UNITED STATES
NUCLEAR REGULATORY COMMISSION
WASHINGTON, D. C. 20555

The Commission has issued the enclosed Amendments Nos. 129 , 129 , and 126 to Facility Operating Licenses Nos. DPR-38, DPR-47, and DPR-55 for the Oconee Nuclear Station, Units Nos. 1, 2 and 3. These amendments consist of changes to the Station's common Technical Specifications (TSs) in response to your request dated February 13, 1984.

These amendments revise the TSs to allow full power operation of Oconee Unit 3 during fuel Cycle 8. We have also revised the administrative numbering of the figures in TS 3.5.2.

Amendment No. 129
License No. DPR-47

CORE PROTECTION
SAFETY LIMITS
UNIT 3
OCONEE NUCLEAR STATION
Figure 2.1-2C

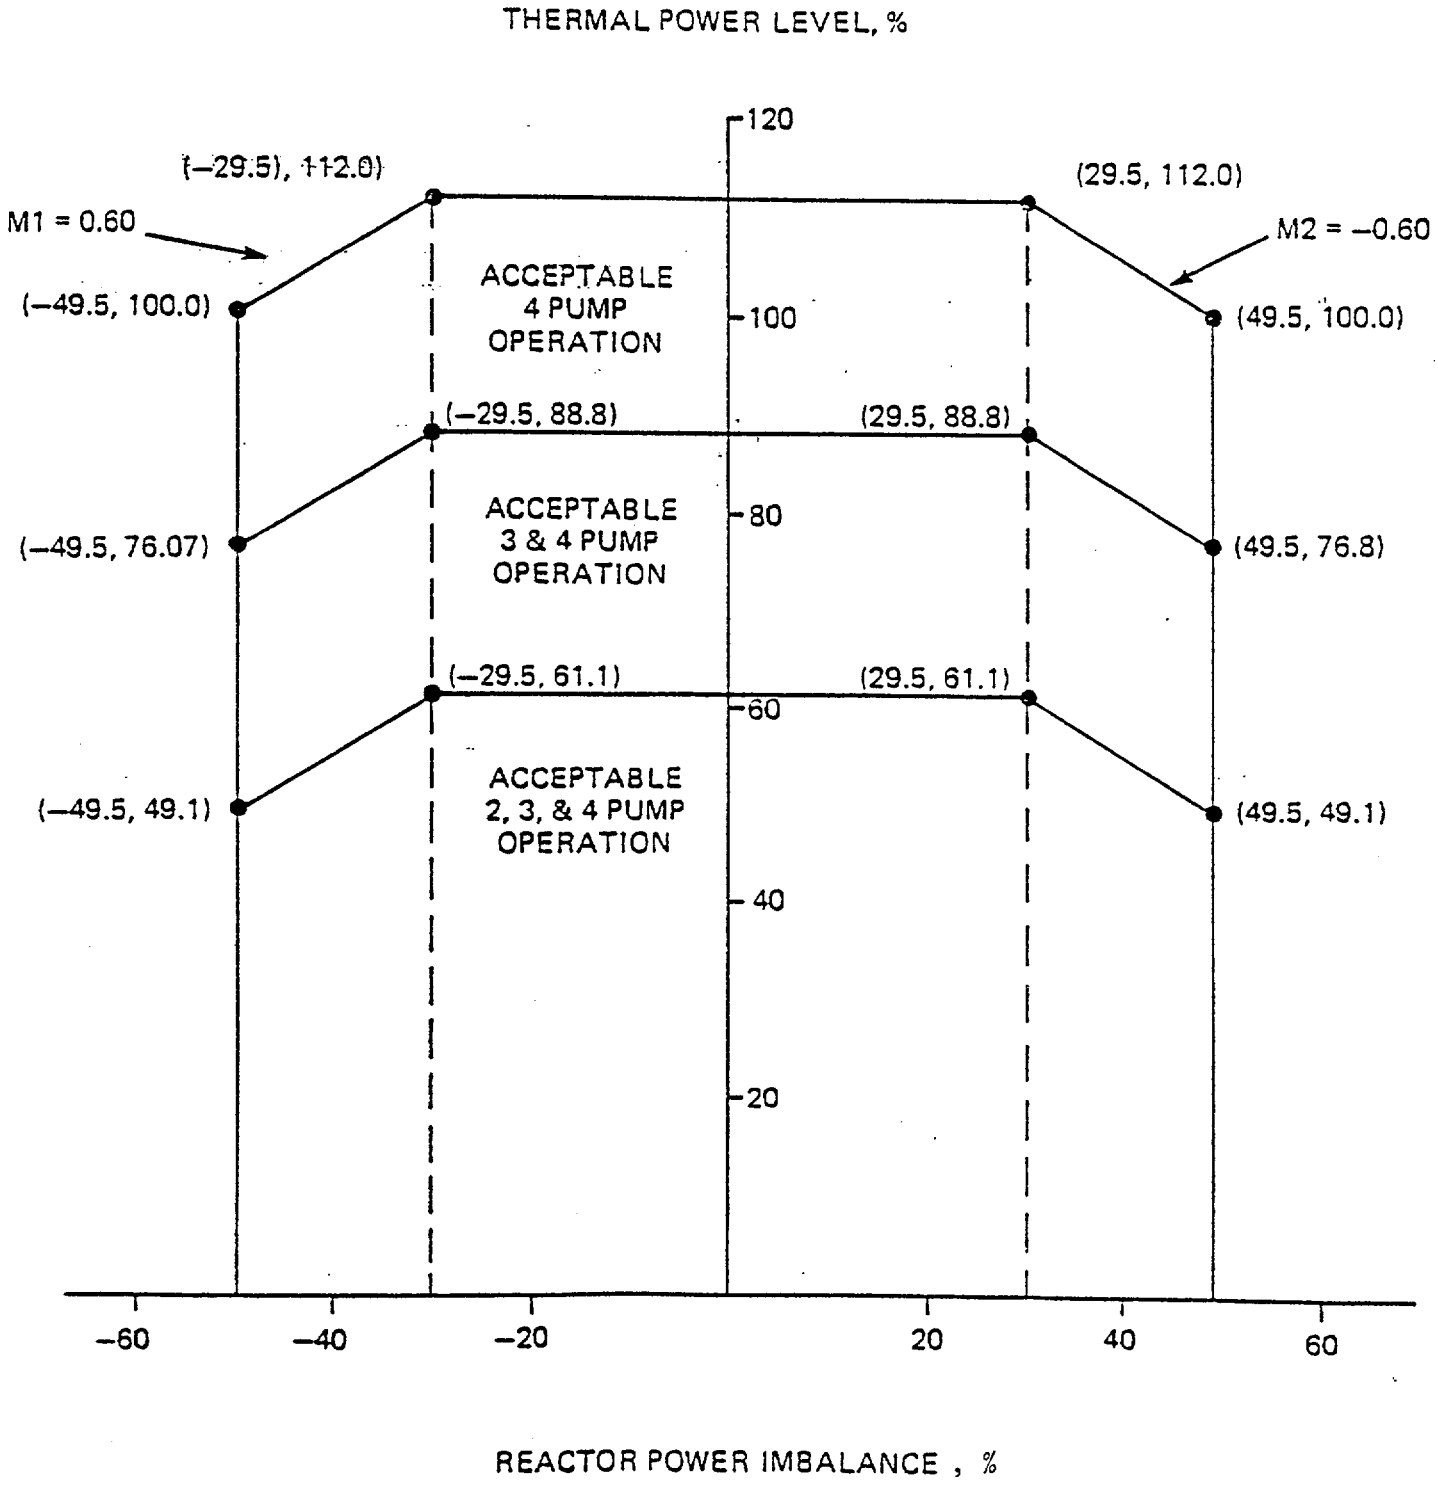
2. The combination of radial and axial peak that causes central fuel melting at the hot spot. The limits for Unit 3 are 20.5 kw/ft for fuel rod burn-up less than or equal to 10,000 MWD/MTU and 21.5 kw/ft - after 10,000 MWD/MTU.

Oconee Unit 3 Cycle 8 Technical Specifications have been modified to account for (i) minor changes in power peaking and control rod worths during Cycle 8 operation, (ii) incorporation of NUREG-0630 data (Ref. 17) in the LOCA analysis and (iii) employment of a Monte Carlo simulation technique in determining instrument string errors (Refs. 18 and 11). We have reviewed the proposed Specification revisions for Cycle 8. These changes concern the (1) Core Protection Safety Limits of Specification 2.1, (2) Protective System Maximum Allowable Setpoints of Specification 2.3 and (3) Rod Position Limits of

PROTECTIVE SYSTEM
MAXIMUM ALLOWABLE
SETPOINTS - UNIT 3
OCONEE NUCLEAR STATION
Figure 2.3-2C

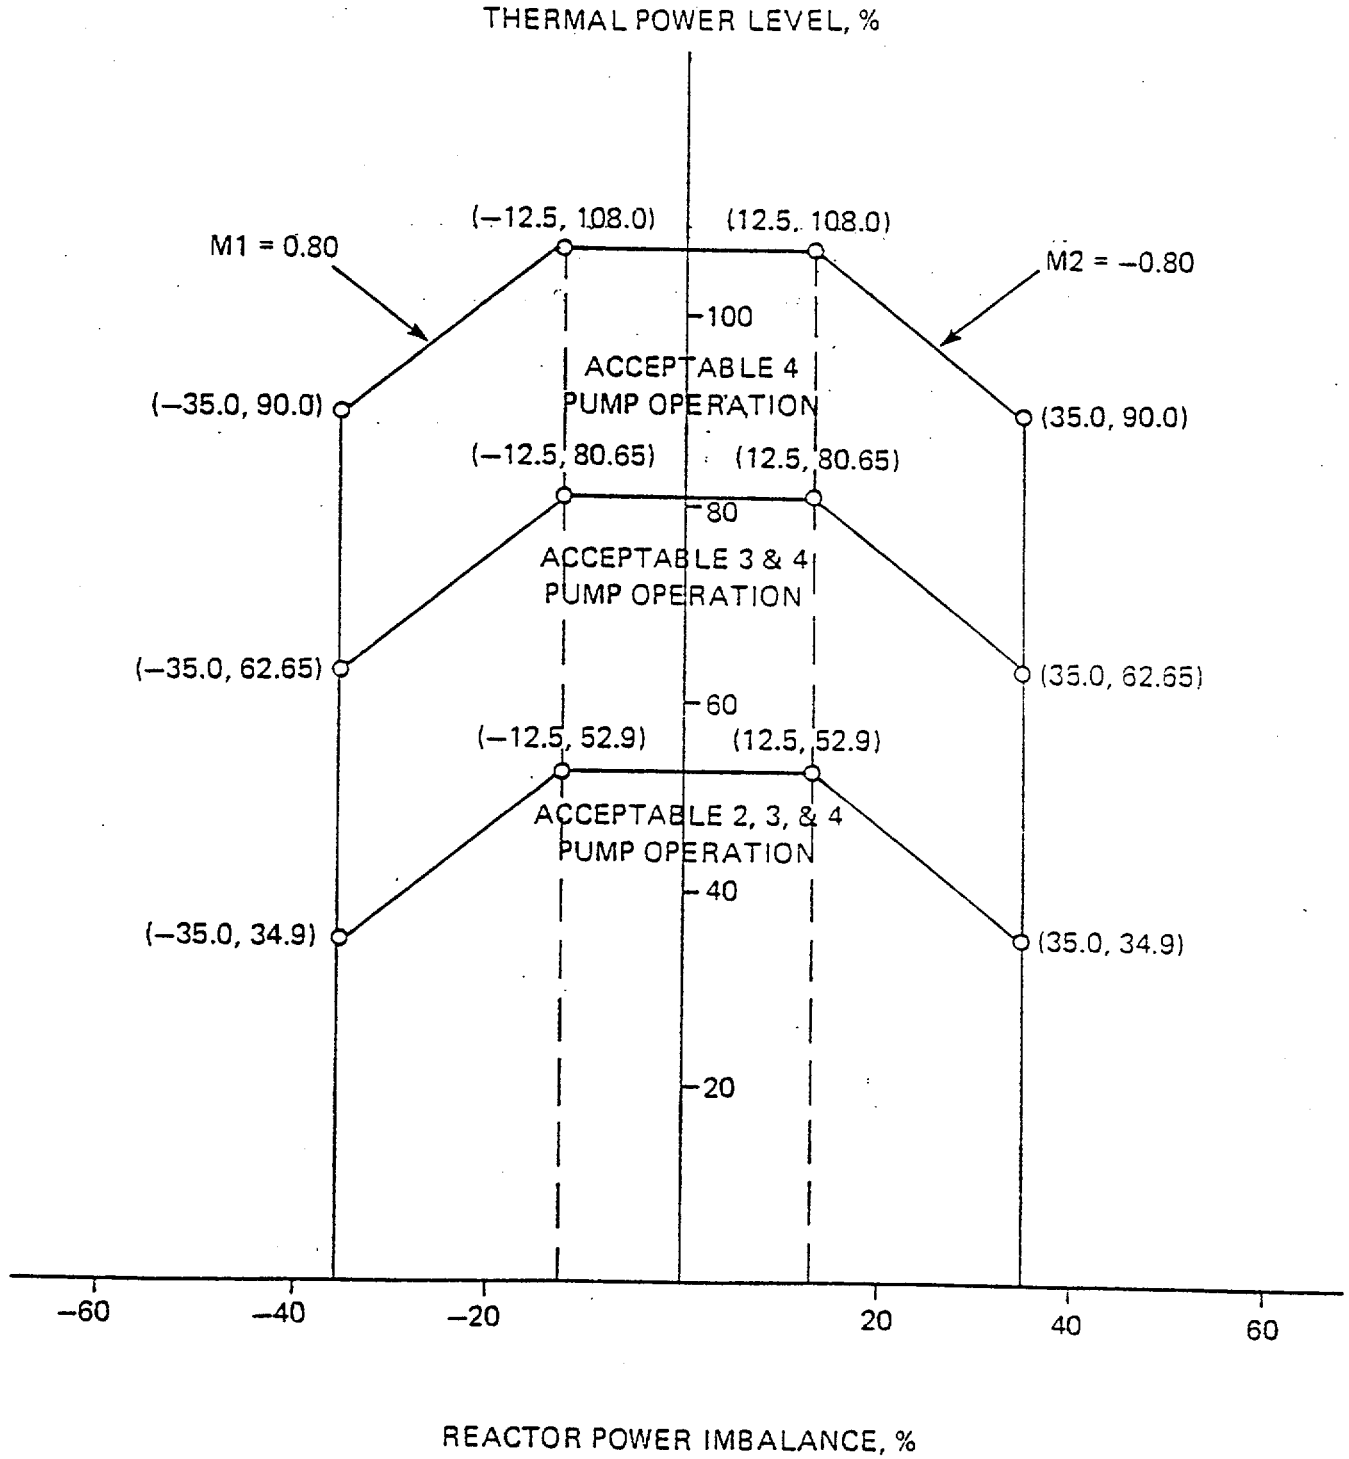
Specification 3.5.2. The limiting safety system settings and the limiting conditions for operation have been established by approved methods. Changes which reflect the core thermal-hydraulic response continue to maintain the safety limit DNBR criterion of 1.30. The control rod withdrawal limits for the various pump combinations and times in core life are presented as well as part length axial power shaping rod position limits. On the basis that previously approved methods were used to obtain the limits, we find these Technical Specification modifications acceptable.
